Consultation report of the Public consultation on the scenario's, sensitivities and data for the CRM parameter calculation for the Y-4 Auction with Delivery Period 2026-27

July 2021

Figure 3.2

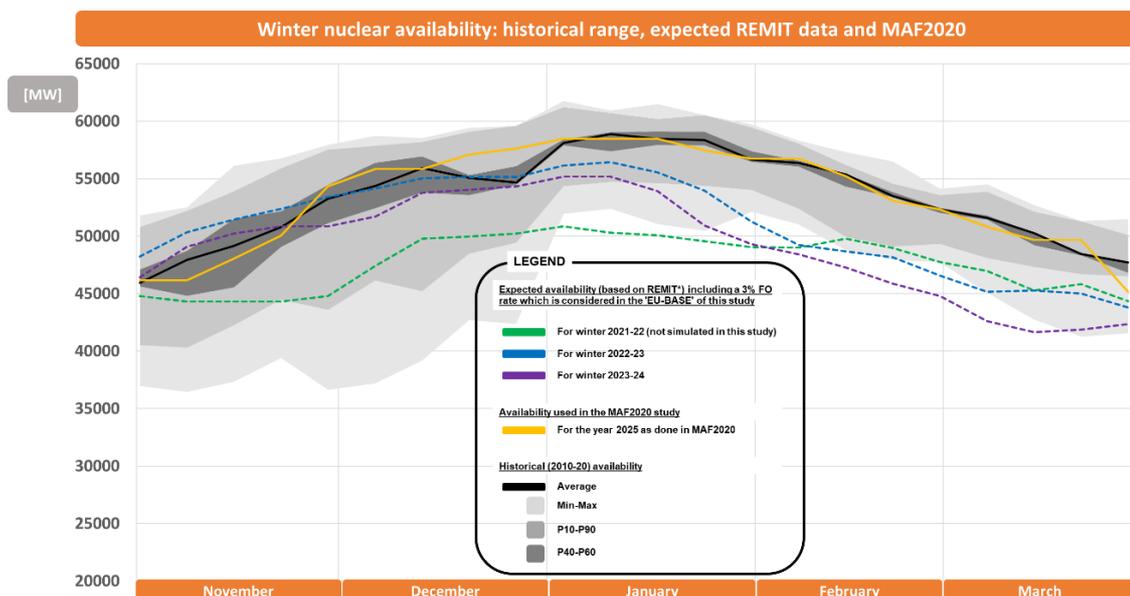
<p>sooner than planned. The shutdown of Dungeness means that by 2024 five of the U.K.'s eight nuclear plants will be halted permanently, adding to a list that includes Hunterston B, Hinkley Point B, Heysham-1 and Hartlepool-1. FEBEG therefore recommends to Elia to integrate in the reference scenario the risk associated with the unavailability of capacities located in neighboring countries, and in particular the unavailability of some French nuclear units..</p>
--	--

Figure 3.2 illustrates this historical range over the past 10 years compared to the deterministic availability used in the MAF2020. As can be observed, the availability of the MAF2020 follows the 10 year average. The future expected availabilities for the next 3 winters of the French nuclear fleet are also indicated on the same figure. The experience of the past years have shown important discrepancies which justify a more prudent and realistic approach.

Despite efforts from French nuclear producers to maximise availability of their units, and to perform the necessary works in due time, there are several reasons to consider a more prudent and realistic approach with regards to French nuclear availability. These are listed below, alongside analysis which justifies the approach taken.
